Access Compliance Report

Public Rights-of-Way

(Curb Ramps)

Intersection ID: 2983	Main Street: YELLOW_ROSE_LN	Cross Street: BROWNE_RD	Location: SW
ADA ID: C5D1E2E50C22	Ramp Type: Perp	Initial Pass/Fail: Fail	Overall Compliance: No
Severity Score: 10			
Codes/Mitigation Info/Possible Solution		Field Measurements/Component Compliance

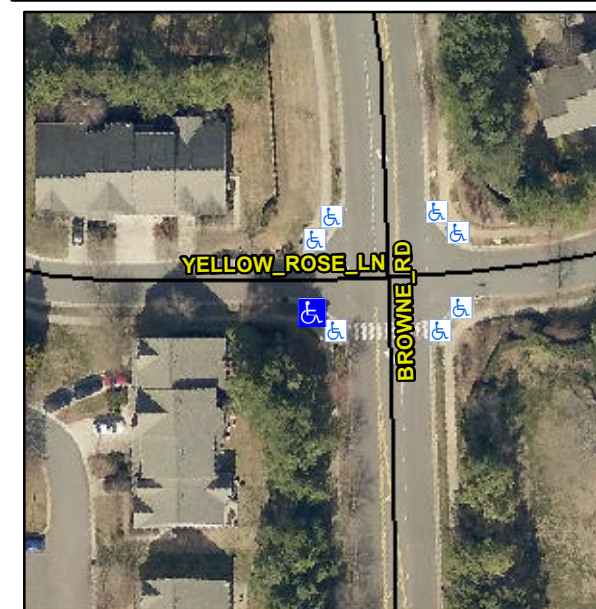
R304.5.1, R304.5.3

Compliance	Description	Data	Compliance	Description	Data
N/A	Ramp Length (in)	68.5	Yes	Ramp Slope (%)	5.3
No	Ramp Width (in)	41.0	No	Ramp XSlope (%)	5.0
N/A	Flare Type LT	N/A	N/A	Flare Type RT	N/A
N/A	Flare Slope LT (%)	N/A	N/A	Flare Slope RT (%)	N/A
N/A	Flare Traversable LT?	N/A	N/A	Flare Traversable RT?	N/A
N/A	Landing Length (in)	N/A	N/A	DWS Provided?	N/A
N/A	Landing Width (in)	N/A	N/A	DWS Contrast?	N/A
N/A	Landing Slope (%)	N/A	N/A	DWS Length (in)	N/A
N/A	Landing X Slope (%)	N/A	N/A	DWS Full Width?	N/A
N/A	Landing Curb? (Y/N)	N/A	N/A	DWS Offset (in)	N/A
N/A	Shared Landing?	N/A			
N/A	Gutter Ponding?	N/A	N/A	Gutter Slope (%)	N/A
N/A	Gutter Lip Ht (in)	N/A	N/A	Gutter X Slope (%)	N/A
N/A	Painted X Walk1?	No	N/A	Painted X Walk2?	N/A
	X Walk 1 Direction	To N		X Walk 2 Direction	N/A
N/A	X Walk 1 Width (in)	N/A	N/A	X Walk 2 Width (in)	N/A
	X Walk 1 Slope (%)	4.3		X Walk 2 Slope (%)	N/A
	X Walk 1 X Slope (%)	2.3		X Walk 2 X Slope (%)	N/A

Remove & Replace Entire Ramp.
